# Access Compliance Report

## Public Rights-of-Way

### (Curb Ramps)

Intersection ID: 8333	Main Street: BROOKSHIRE_BV	Cross Street: S_I-85_EXIT_36_RA	Location: NE
ADA ID: A28BB4431C13	Ramp Type: Perp	Initial Pass/Fail: Fail	Overall Compliance: No
			Severity Score: 21.25

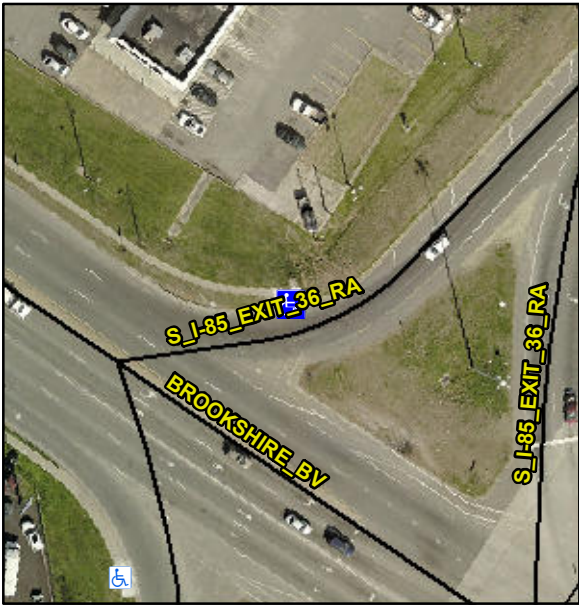
Codes/Mitigation Info/Possible Solution			Field Measurements/Component Compliance					
	Possible Solutions:		Compliance	Description	Data	Compliance	Description	Data
	Remove & Replace Entire Ramp.		N/A	Ramp Length (in)	54.0	No	Ramp Slope (%)	10.3
			No	Ramp Width (in)	42.0	Yes	Ramp XSlope (%)	0.1
			N/A	Flare Type LT	N/A	N/A	Flare Type RT	N/A
			N/A	Flare Slope LT (%)	N/A	N/A	Flare Slope RT (%)	N/A
			N/A	Flare Traversable LT?	N/A	N/A	Flare Traversable RT?	N/A
			N/A	Landing Length (in)	N/A	N/A	DWS Provided?	N/A
			N/A	Landing Width (in)	N/A	N/A	DWS Contrast?	N/A
			N/A	Landing Slope (%)	N/A	N/A	DWS Length (in)	N/A
			N/A	Landing X Slope (%)	N/A	N/A	DWS Full Width?	N/A
Surveyor Notes:	N/A		N/A	Landing Curb? (Y/N)	N/A	N/A	DWS Offset (in)	N/A
			N/A	Shared Landing?	N/A			
	PROW/ADA:		N/A	Gutter Ponding?	N/A	N/A	Gutter Slope (%)	N/A
	Not Found, R304.5.1, R304.2.2		N/A	Gutter Lip Ht (in)	N/A	N/A	Gutter X Slope (%)	N/A

N/A	Painted X Walk1?	Yes	N/A	Painted X Walk2?	N/A
				X Walk 1 Direction	To SW		X Walk 2 Direction	N/A
			N/A	X Walk 1 Width (in)	55.0	N/A	X Walk 2 Width (in)	N/A
				X Walk 1 Slope (%)	6.4		X Walk 2 Slope (%)	N/A
				X Walk 1 X Slope (%)	0.6		X Walk 2 X Slope (%)	N/A
			N/A	Ramp inside XWalk1?	Yes	N/A	Ramp inside XWalk2?	N/A
			Road Slope (%)	N/A	N/A	Clear Space?	N/A	
			Road X Slope (%)	N/A	N/A	Clear Space to XWalk (in)	N/A	
		N/A	Any Obstructions?	N/A	N/A	Storm Grate/Utility Hazard?	N/A	
			Obstruction Type			Storm Grate/Utility Type		
					N/A		N/A	
					Yes	Surface Condition? (G/P)	Good	
Total Cost:		\$ 1850.00
